SERVICE NOTE

6573A-05A

6573A DC POWER SUPPLY MANUALLY CONTROLLED

The Current Shunt (Circuit Reference "R907") may have intermittent sense wires, which may cause Instability of Current regulation, Current read back and current programming.

A6 Output Assembly for Models (65/6673A, 74A, 75A & E4356A) This picture shows how the Shunt R907 is connected using the term-crimp connectors. The Shunt R907 is connected to "W900" & "W901"

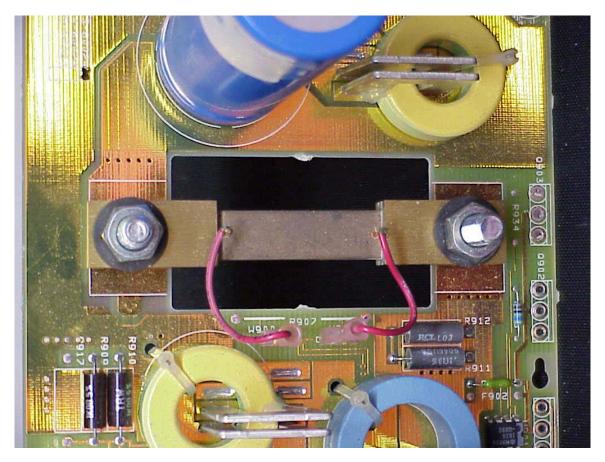
When the push-on connectors become intermittent the output current will become unstable. Loose push-on connectors can cause the output current to change dramatically. The current can change from any set current, and may go to the maximum rated output current of the instrument.

Cut the terminal-crimp connectors off of both wires and discard the connectors. Make this cut as close to the terminal-crimp connector as possible. The required strip length should be 5mm. This strip length will be used to prevent the wire length being too long and shorting to the instrument chassis. If replacement of this wire is required any color (22 AWG. 300V 105C) wire type can be used.

This modification can be done from the top of the board. Carefully strip and solder the wires, and avoid burning the wire insulation and the printed circuit board.

The wires should be connected as shown below. There are two holes marked R907 that should be used. Do not cross the wires when making this modification. See picture below for details. This picture shows the required modification.
